TOWN OF LOS GATOS PLANNING COMMISSION AGENDA JUNE 09, 2021 110 EAST MAIN STREET LOS GATOS, CA

Requesting Approval for Demolition of an Existing Single-Family Residence and Construction of a New Single-Family Residence with Reduced Front and Side Setbacks on Nonconforming Property Zoned R-1:8. Located at **102 Alta Heights Court**. APN 532-29-045. Architectural and Site Application S-20-029. Property Owner: Bo Development, LLC. Applicant: Eric Beckstrom. Project Planner: Ryan Safty.

DATE: June 4, 2021
TO: Planning Commission
FROM: Joel Paulson, Community Development Director
SUBJECT: Requesting Approval for Demolition of an Existing Single-Family Residence and Construction of a New Single-Family Residence with Reduced Front and Side Setbacks on Nonconforming Property Zoned R-1:8. Located at 102 Alta Heights Court. APN 532-29-045. Architectural and Site Application S-20-029. Property Owner: Bo Development, LLC. Applicant: Eric Beckstrom. Project Planner: Ryan Safty.

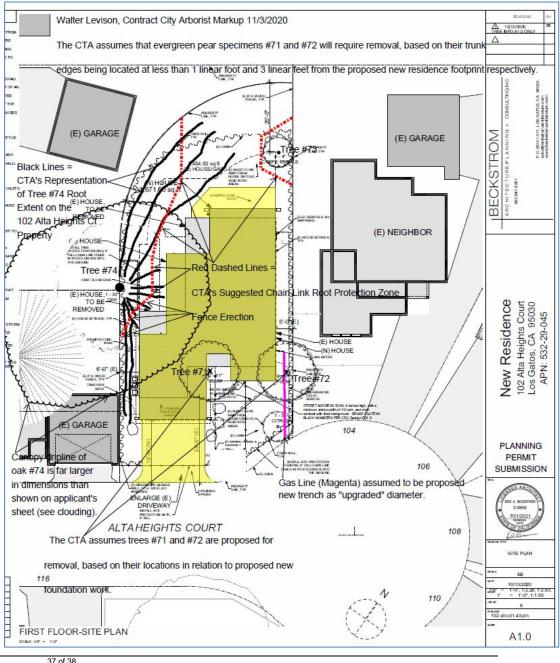
The canopies of trees #71 and #72 as indicated on the applicant's sheet A1.0 is not accurate. The canopy spread of each of those trees is actually 30 feet diameter. The applicant's sheet A1 indicates canopy spreads of only 18 feet diameter for each of these trees.

Note that the canopy dripline of oak #74 is far greater in dimensions than shown on the applicant's original proposed sheet A1.0.

The black clouding indicating on the CTA's markup at right is roughly to scale, and is a more accurate albeit crude representation of the extent of this very large tree specimen.

Note: As indicated above in this report, the applicant's original sheet A1.0 shows the canopy driplines of trees #71, 72, and #74 at dimensions far smaller than actual. The CTA enlarged the tree #74 canopy in the marked up image at right to rough- scale dimensions.

The tree protection fencing will need to be erected at roughly 7 to 8 feet east of trunk of oak #74, but will extend 50 feet northward per the markup at right, in order to protect as much square footage of the tree's lateral woody root system extending along the 102 Alta Heights Ct. property.

PROPOSED RIGHT SIDE ELEVATION

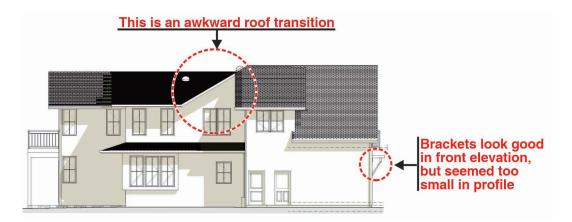
I reviewed the architects' portfolio of work on their website, and found that they have substantial successful experience in designing contemporary homes in a convincing range of traditional styles. I have only a limited number of issues to bring to staff's attention.

<u>S-20-</u>029, Architecture Response

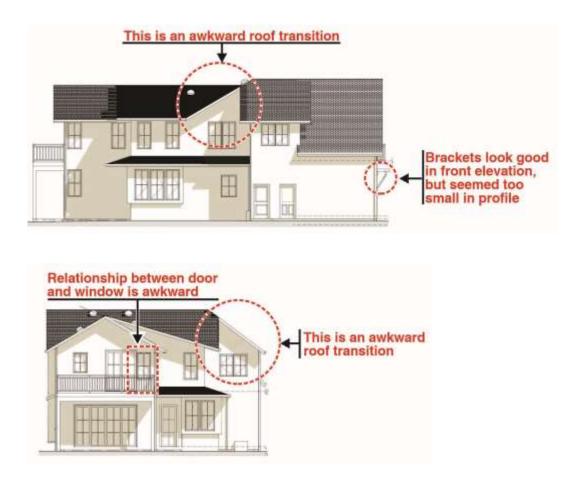
3. The trellis brackets over the garage door look good as drawn on the front elevation, but seem too small in profile.

Response: See A3.3, brackets size increased width
